# Pioneer Park

Pioneer Park is medium sized neighborhood park that provides parking, a portable toilet, playgrounds, picnic area, benches and open field for soccer. The main issues at this park are the parking spaces needing to be restriped, provide a fine sign, slopes, benches with companion seating, trash cans on accessible routes, and curb ramps with truncated domes. **Please Note:** When a **UD** is indicated, this is a Universal Design (**UD**) recommendation to enhance accessibility. The **UD** recommendation is not required to meet the minimum accessibility standards but it would be encouraged.

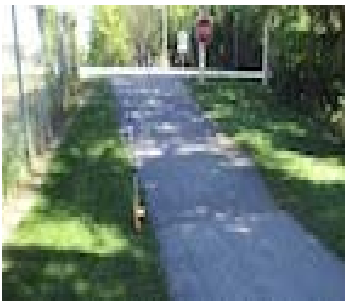
Photo	Barrier	ADAAG/IAC	Solution	Priority	By Whom	Projected Cost	Projected Date	Action Taken
	<p>The trash can near the picnic table is not on an accessible route for 6' and the trash can near the sign is not on an accessible route for 8'.</p>	<p><b>Proposed</b> Outdoor Developed Areas Guidelines 1011</p>	<p><b>Trash Can Recommendation:</b> Locate trash cans on an accessible route as part of your regular policy. For a forward approach provide a trash can within 24" and a minimum clear ground space of 36" by 48" or for a side approach provide a trash can within 24" and a minimum clear ground space of 30" by 60".</p>			\$50	2025	<p>Reorganize and replace during replacement of playground and surfacing</p>
	<p>The walkway in front of the bench at the soccer field has a cross slope too steep at 2.6% to 5.9% for 25'.</p>	<p>ADAAG 403.3</p>	<p>Remove and regrade section to provide a cross slope no greater than 2%.</p>			\$825	2025	<p>Reorganize and replace during replacement of playground and surfacing</p>

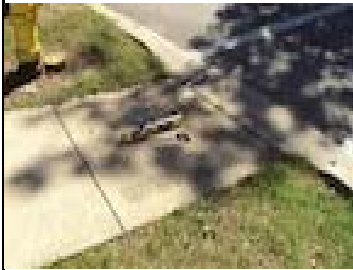
Photo	Barrier	ADAAG/IAC	Solution	Priority	By Whom	Projected Cost	Projected Date	Action Taken
	The walkway up to the stop sign has a running slope too steep at 9.6% to 16.5% for 31'.	ADAAG 403.3	Remove and regrade section to provide a running slope no greater than 5% and a cross slope no greater than 2%. Because of the slope in this area regrading to 5% may not be possible. Follow ADAAG 405 for ramps if necessary. Because of the terrain in this area, you may only be able to lessen the slope to the greatest extent possible.			\$2,575	2019	Replace paths as part of Capital project
	Along the walkway under the tree there is a trash can located in the grass and 7' off the accessible route.	<u>Proposed</u> Outdoor Developed Areas Guidelines 1011	<b>Trash Can Recommendation:</b> Locate trash cans on an accessible route as part of your regular policy. For a forward approach provide a trash can within 24" and a minimum clear ground space of 36" by 48" or for a side approach provide a trash can within 24" and a minimum clear ground space of 30" by 60".			\$50	2012	Moved can to accessible route 4/2012

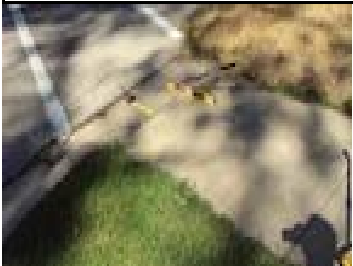
The sidewalk to the west curb ramp has a running slope too steep at 1.6% to 12.5% for 6'.	ADAAG 403.3	Also provide a smooth transition to the remaining walkways.			\$1,500		Coordinate with City's sidewalk replacement schedule
